Shop Drawing Submittal Review

Project Name: Webster University-**ISB**

Copies	No.	Description
1 PDF	224216P02	(Submittal No.'s)
		(Cannon #22 4216.16-001) - (Paric #15051-) – (WES #607)
		➢ **Commercial Sinks**
		• Clinical Service Sink CSS-1
		• Scrub Sink SS-1
		• Sink SK-1
		• Garbage Disposer GD-1
		• Sink SK-2
		• Sink SK-3
		• Mop Sink MS-1
		• Kitchen Sinks KS-1, KS-2, KS-3

PROJECT NAME:	Webster University ISB
LOCATION:	St. Louis Missouri
CLIENT PROJ. NO.:	N/A
WES PROJ. NO.:	607
SPEC SECTION:	22 4216.16 Commercial Sinks
SUBMITTAL ITEM:	See Below -

PFE1

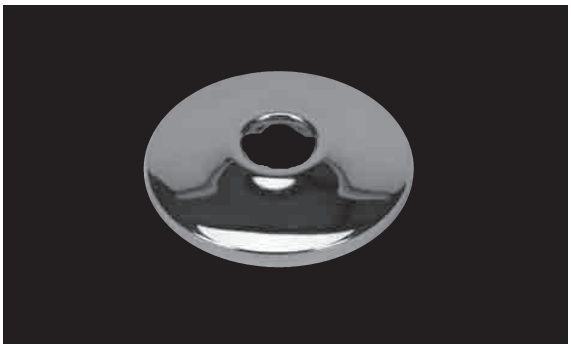
1. Provide under counter waste and supply protective piping covers as required. Verify requirements with the architectural drawings.
.
2. Escutcheons are specified to be cast brass. Refer to specification section 220518.
